PLAN OF PROPOSED HOUSE

ON PLOT NO. 23 & 23 A

OLD TOWN QUARTER

Nº 685

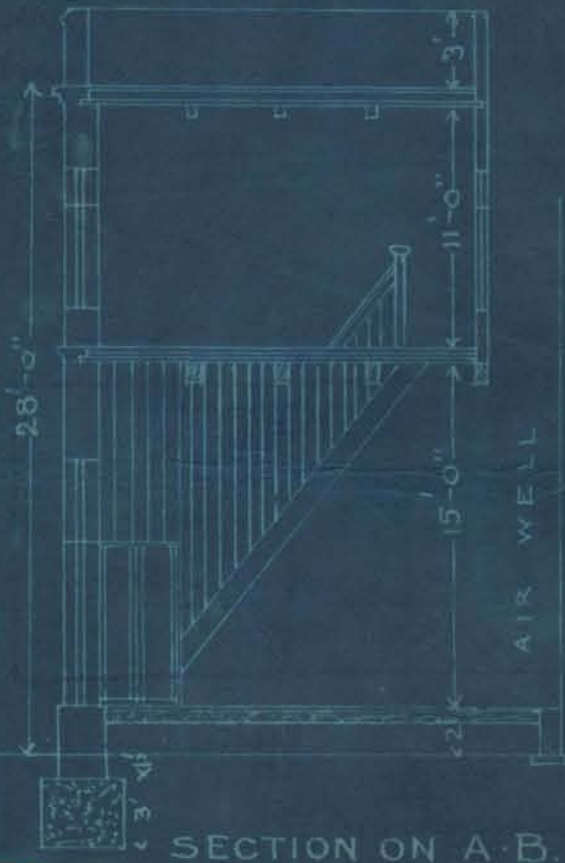
In continuation of this office No. E 5397 dated 21st June 1917 Mr: Amanmal Ladhamal is informed that the Collector is not prepared to sanction his plan relating to plot Nos. 23 & 23A, A-8 Old Town Quarter because the bath room and water closet are located in the only living room on the first floor. The Collector suggests that they should be located on the ground floor and plans amended accordingly which are returned herewith.

With reference to your endorsement No: E/5398 dated 21st June 1917, approving the accompanying plan No: 685 of the proposed buildings to be built on survey numbers 23 & 23A (sheet A-8) Old Town Quarter, I have the honour to inform you that the Collector of Karachi is unable to sanction the plan because ^{the} both room and waster closet are located in the only living room on the first floor. The Collector suggests that they should be located on the ground floor.

He is further directed to apply to the City Deputy Collector for amalgamation of the two Survey Nos. 23 & 23A, A-8 with out which his plan will not be considered.

2/- The applicant may also kindly be directed to apply for amalgamation of the two survey numbers.

PLAN OF PROPOSED HOUSE

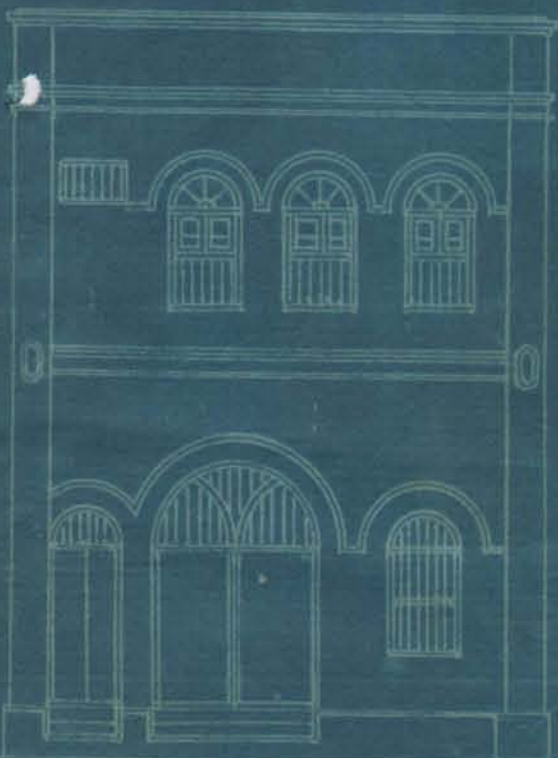
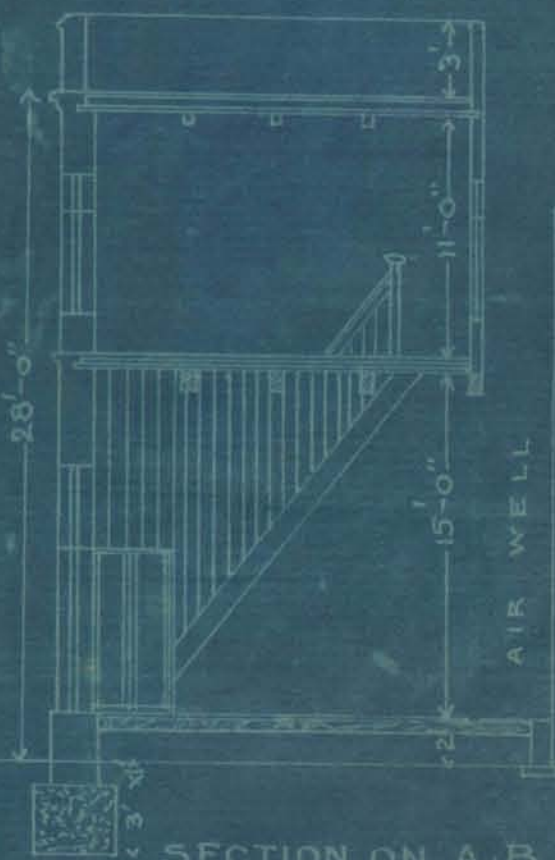
Referring to his application dated 13th April 1917 with plans for building a house on plot No. 23 & 23A, A-8 Old Town Quarter Mr: Amanmal Ladhamal is informed that the ~~the~~ block plan as submitted is incorrect and does not tally with the Survey Sheet. The plans are therefore returned herewith for amendment accordingly.

With reference to this they
to report that ~~that~~ the block
plan is incorrect it does
not tally with the survey
sheet. Request your order.

are old Jinnah Quarters, with the
black plan duly corrected. I beg
